PWC suggested changes to Circulation Element

ND Notes on Draft April 10 2013 Circulation and Roadways Element

Bikeways Map, Figure C-5 of the Circulation Element

Figure C-1

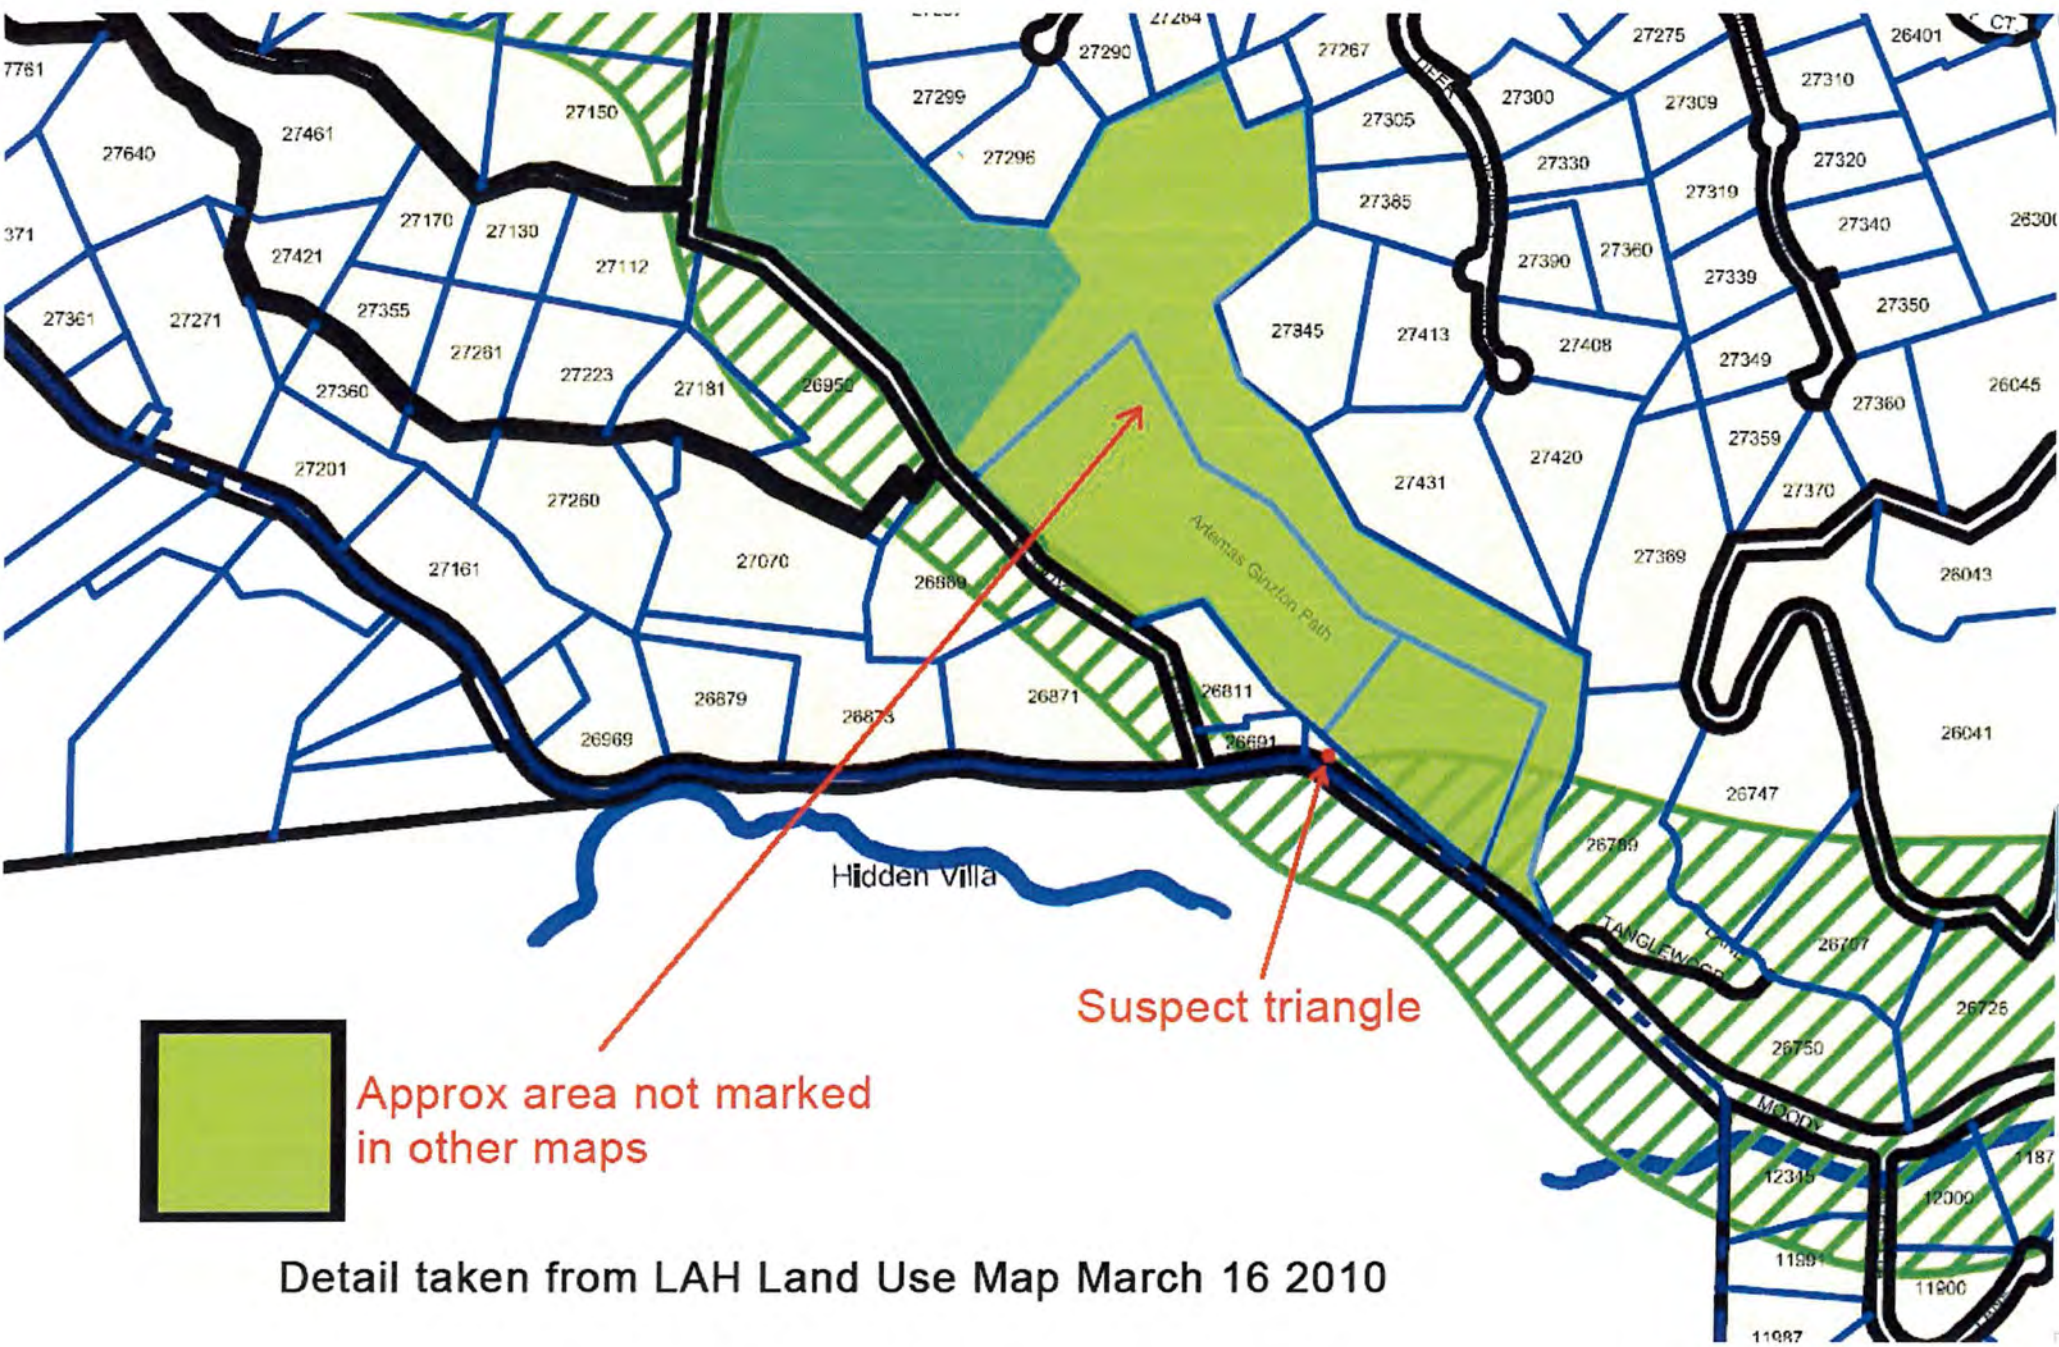
This is a comment on the draft document from last night's meeting on Circulation & Scenic Roadways Element, but I'll copy Debbie as well because it pertains to some underlying map (GIS File?) that appears to be incorrect and that the town is using for multiple purposes. i.e. it is this underlying file that probably needs correcting rather than just the one in the shown in the Circulation & Scenic Roadways element of the General Plan

a) **CirculationElementFigureC1.pdf** – this figure C1 is on Page C-4 of last nights document - I have marked it up with a red circle on the problem area

Detail taken from LAH Land Use Map March 16 2010

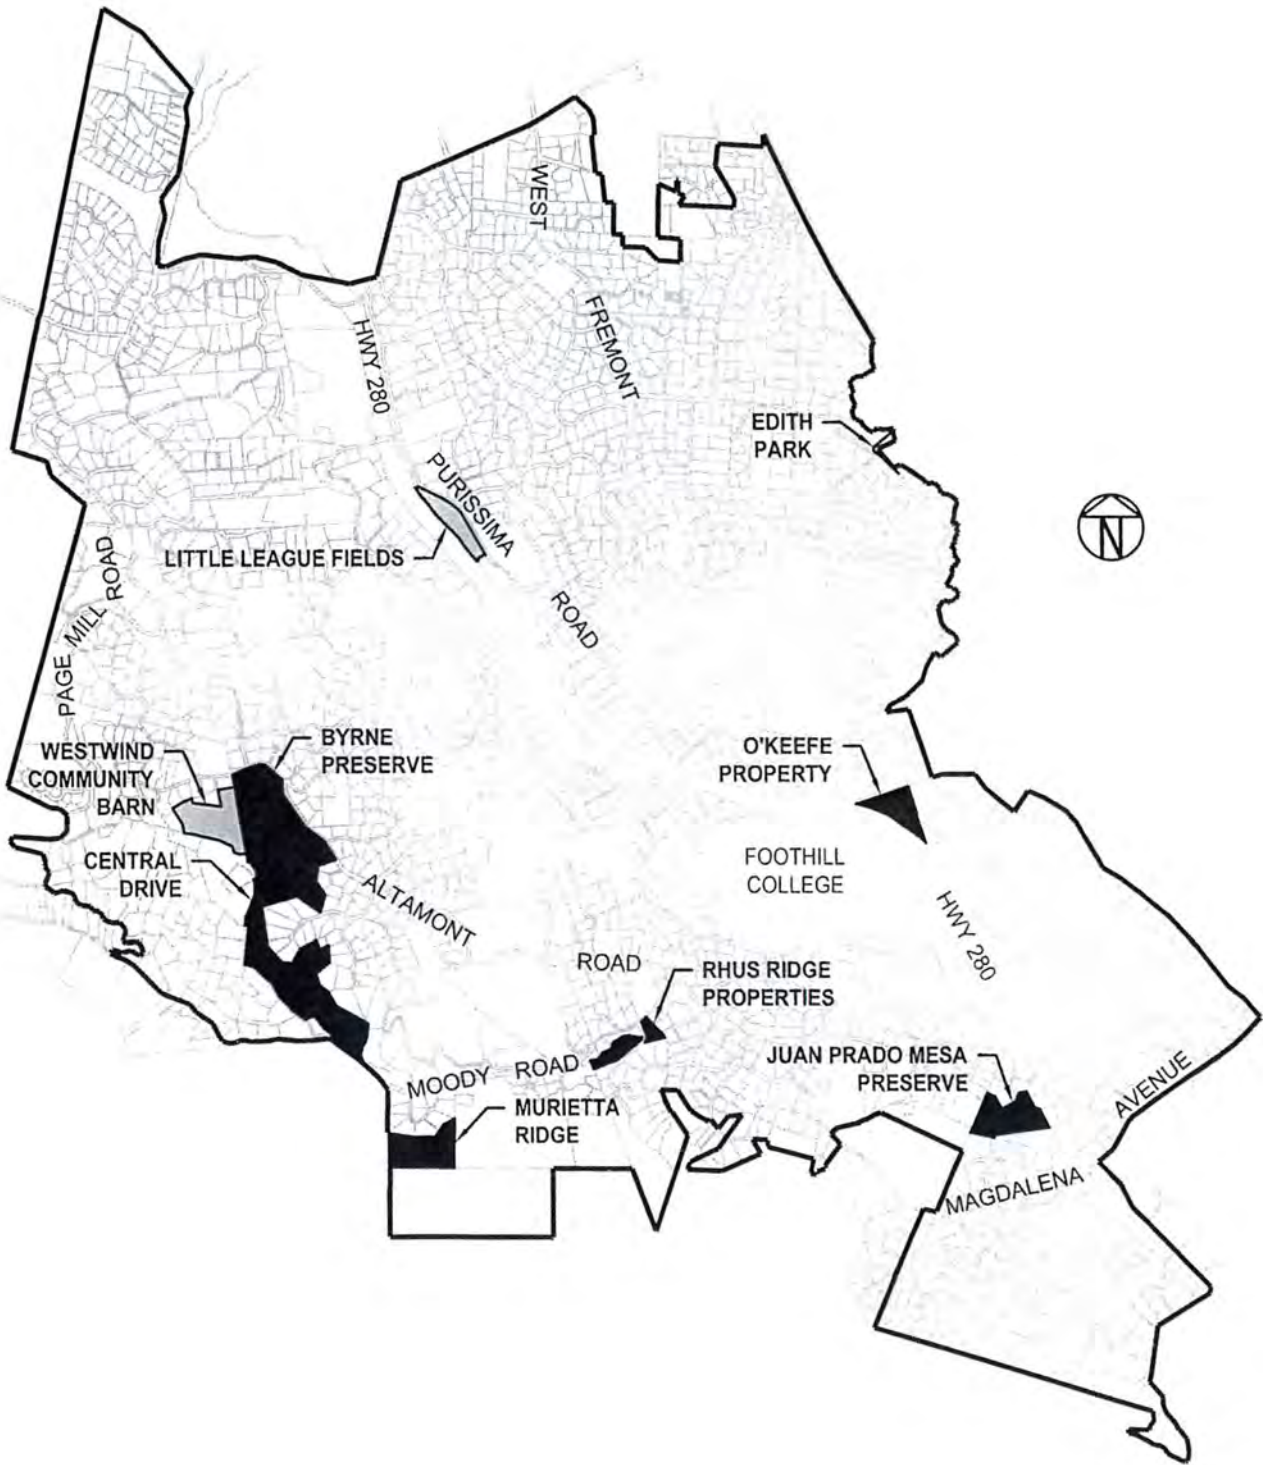
b) **Detail.pdf** – This is an enlargement of the subject area snipped from "LAH Lands Use Map dated March 16 2010". This shows the extra parcels that should be marked as open space on (a) above – **BUT** – even this map has a problem I think – see the small chunk I have marked as "Suspect Triangle". If this isn't open space belonging to the town, then whose is it???
